AMENDMENTS TO THE DRAWINGS

The attached sheets of drawings include changes to FIGS. 1-7, 9 and 10. These sheets replace the original sheets. The annotated sheets show the proposed changes to FIGS. 1, 2, 9 and 10 that accompanied the Letter to the Official Draftsperson filed with the Amendment dated January 13, 2003, proposed changes to FIGS. 3-5 labeling these figures "BACKGROUND ART" to be consistent with the labeling of FIGS. 1 and 2, and proposed changes to FIGS. 6 and 7 to show separate signals being outputted from the first low pass filter 103 to the phase perceiving part 104 and the microcomputer part 105, respectively, and a variation determination unit 105d coupled between the mixing unit 105c and the CRCP 105b.

Attachments: Replacement Sheets
 Annotated Sheets showing changes to FIGS. 1-7, 9 and 10

FIG. 3

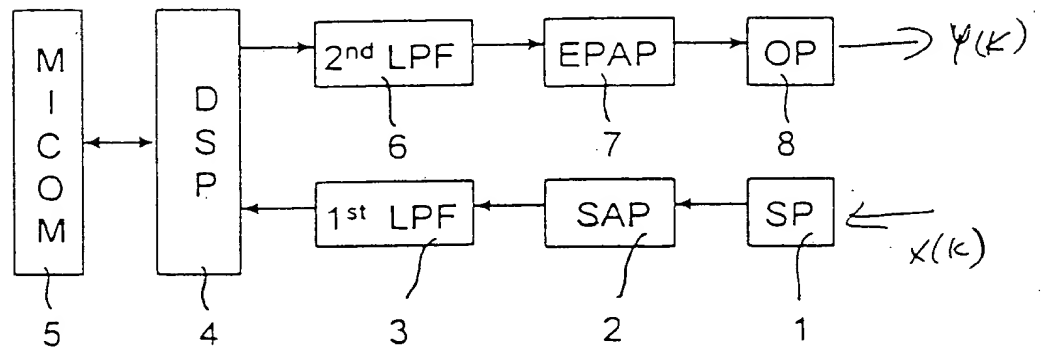
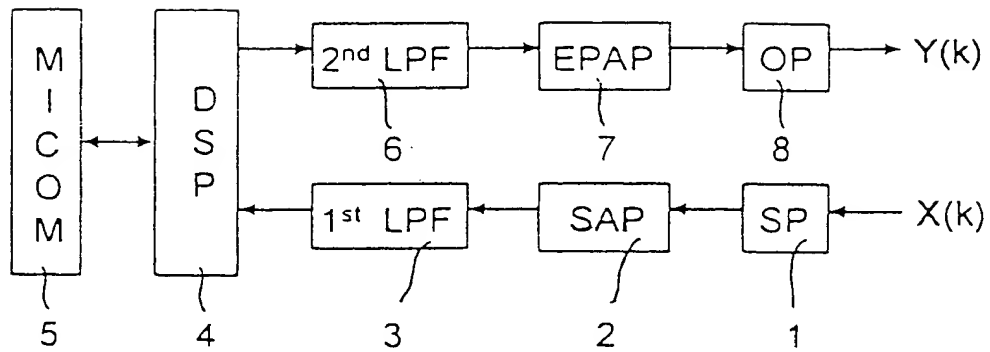
~~PRIOR ART~~ BACKGROUND ART

FIG.3
BACKGROUND ART

FIG. 4

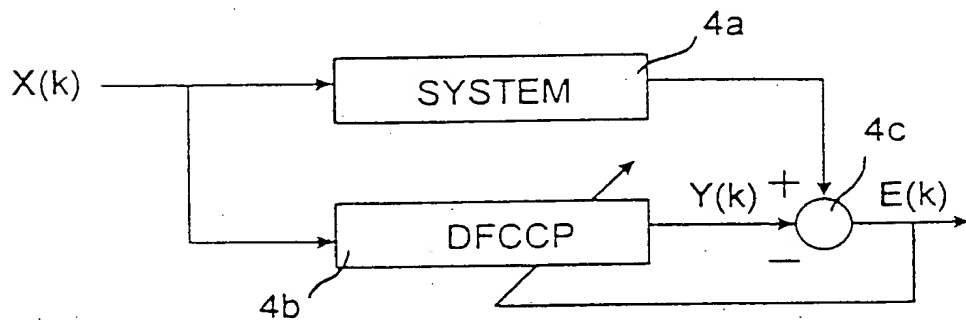
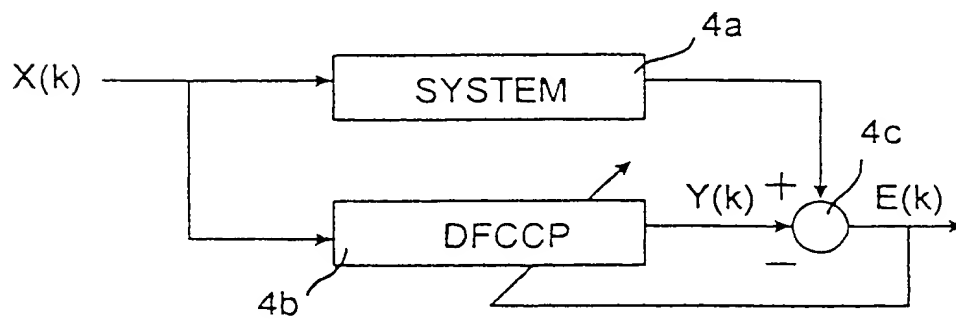
~~PRIOR ART~~ BACKGROUND ART

FIG.4
BACKGROUND ART

FIG. 5

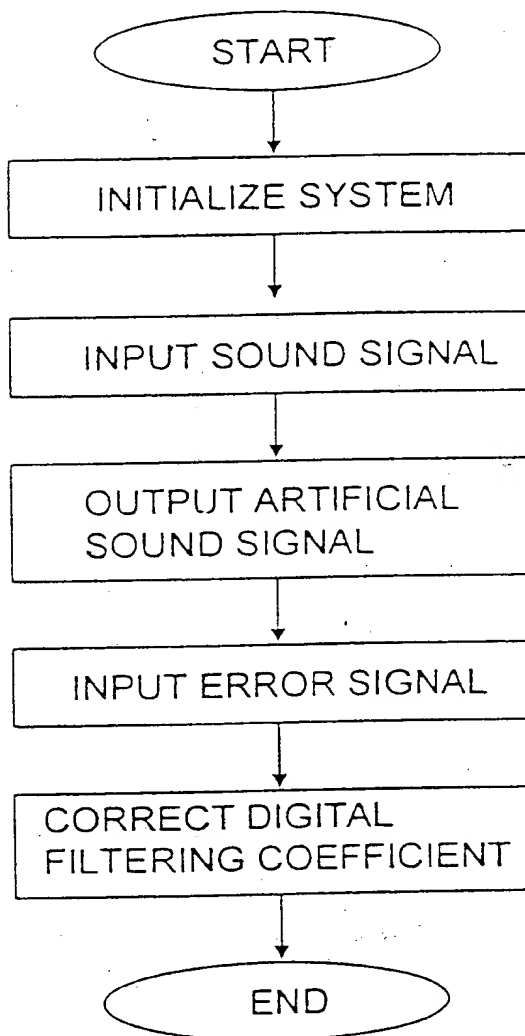
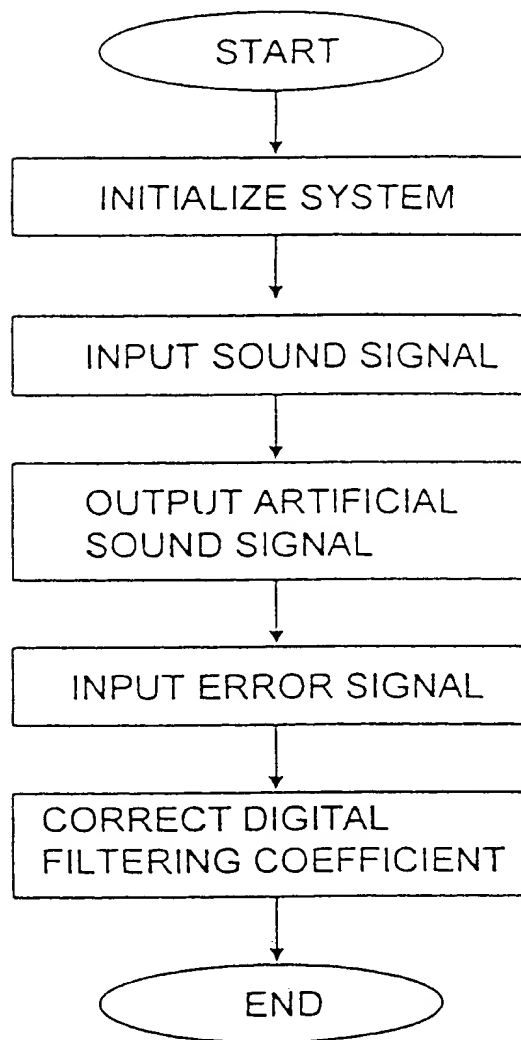
~~PRIOR ART~~

BACK GROUND
ART

FIG.5
BACKGROUND ART
